MOBILE TABLE

SUBMITTAL IDENTIFICATION SHEET

WEBSTER UNIVERSITY ISB	
PROJECT NAME	
8274 BIG BEND BLVD	
ADDRESS	
NUMBER	
WEBSTER UNIVERSITY	
OWNER	
CANNON DESIGN	
ARCHITECT / ENGINEER	
DEVIN D GATES	
SUBMITTED BY	
123553-001 REV 2	
CONTRACTOR / CM SUBMITTAL NO.	CANNON DESIGN SUBMITTAL NO.
	123553
DRAWING / DETAIL REFERENCE	SPECIFICATION SECTION / PARAGRAPH
MANUFACTURER / SUPPLIER	ITEM / PRODUCT ID
REQUIRED DATE	PRIORITY
	CRITICAL

DATE: 1/25/2017
JOB: 04437A, B, C, D
RE: Webster University
Webster Groves, MO

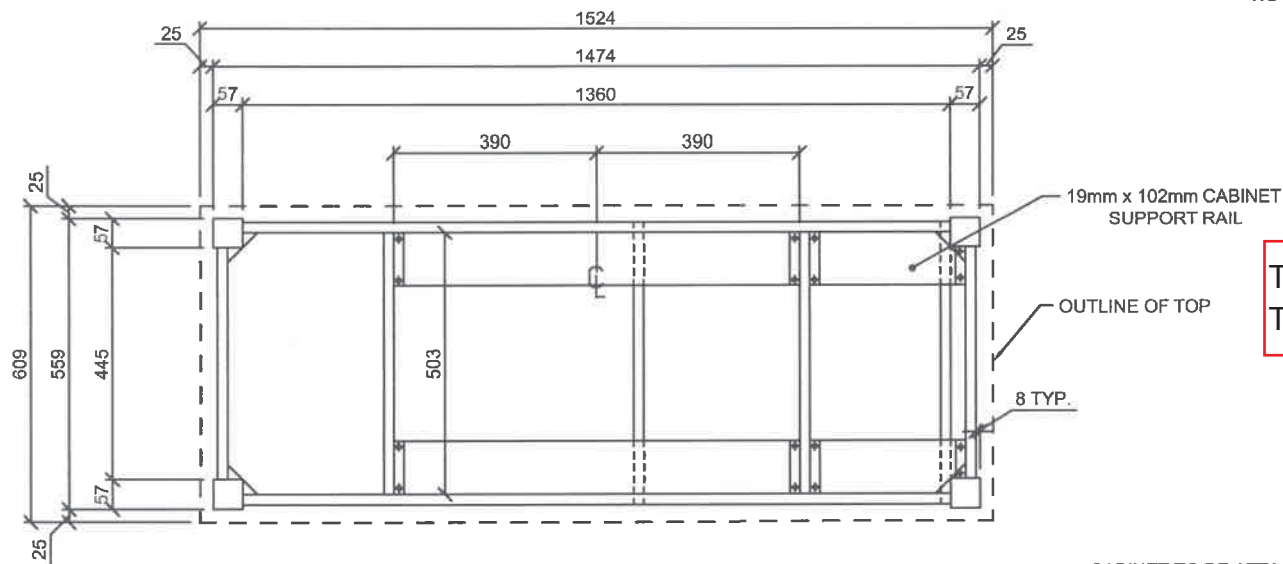
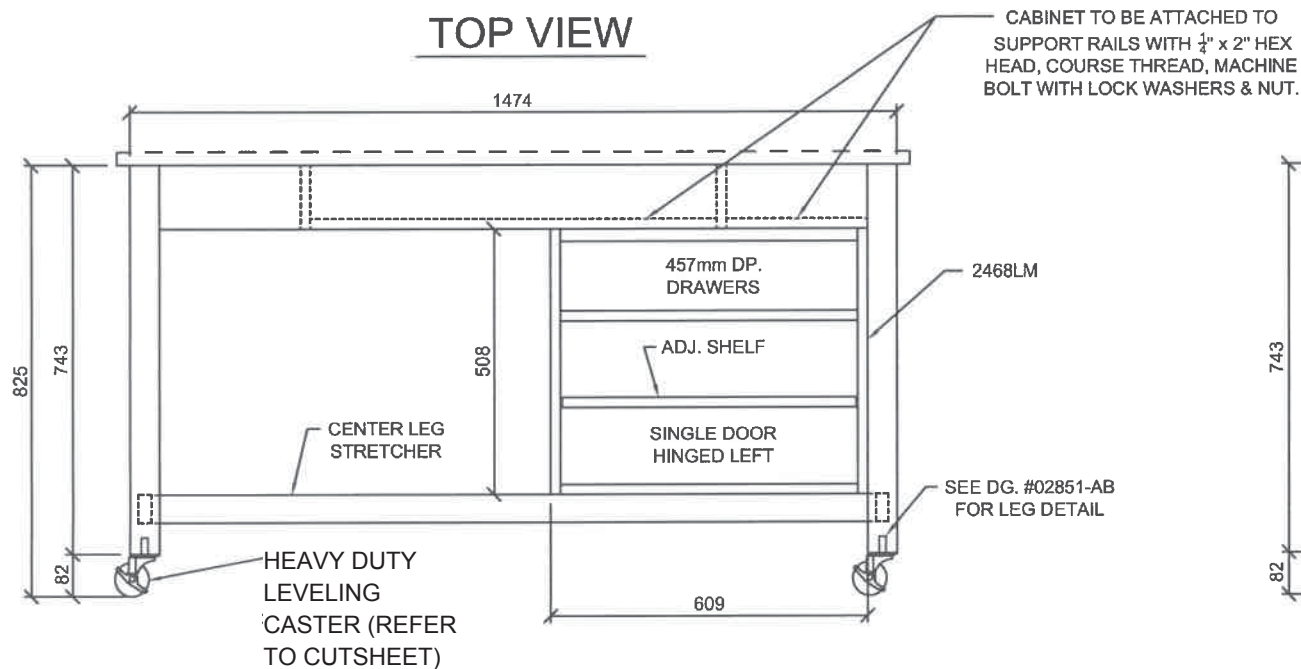
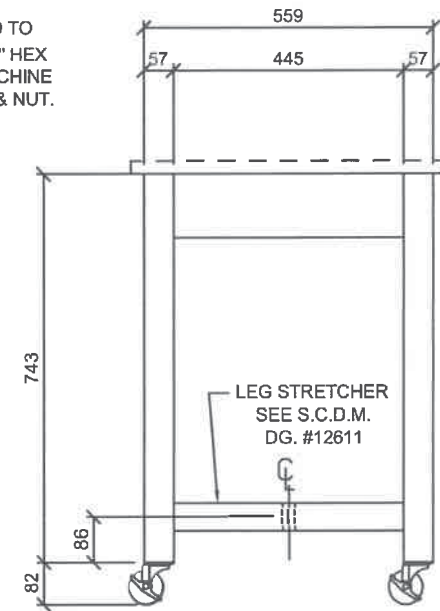
-TABLES TO MEET UL REQUIREMENT PER SPECIFICATION 123553,1.3,D.

-PROVIDE LOAD CAPACITY OF TABLES.
